## Memo from Community Development Engineering

Re: CUP24-1001 CHS Tennis Courts – Hearing Continuation

## Preliminary Plat for Camas Woods Subdivision (SUB24-1002)

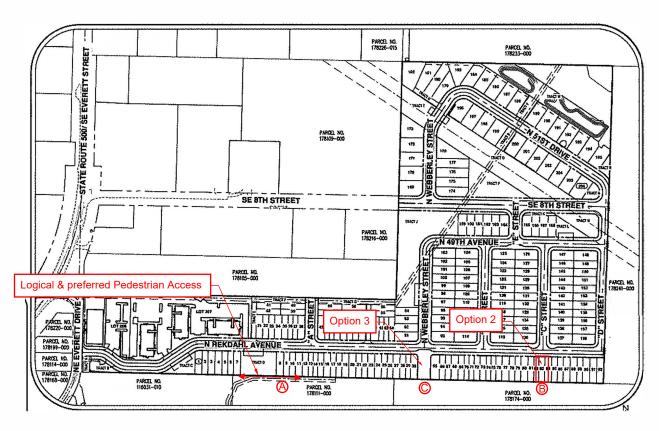
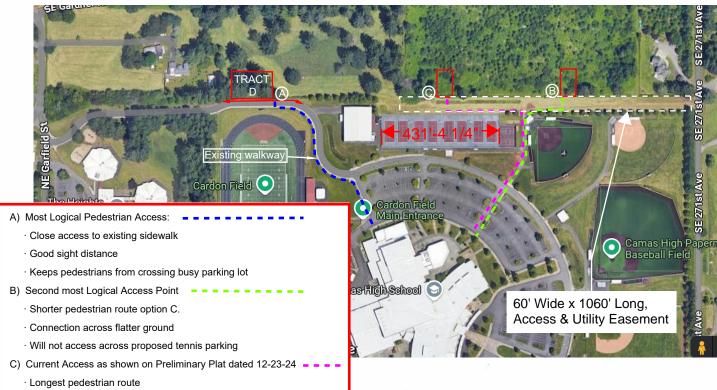
**FINDING:** Staff finds that, due to site distance and ease of pedestrian access, the preferred pedestrian access location from the proposed Camas Woods development to the Camas High School property is Option A, "Logical & preferred Pedestrian Access", as shown on the attached map provided by MacKay Sposito.

· Connection point to school site has most grade issues

· Option has crosses existing parking lot and proposed tennis parking lot.
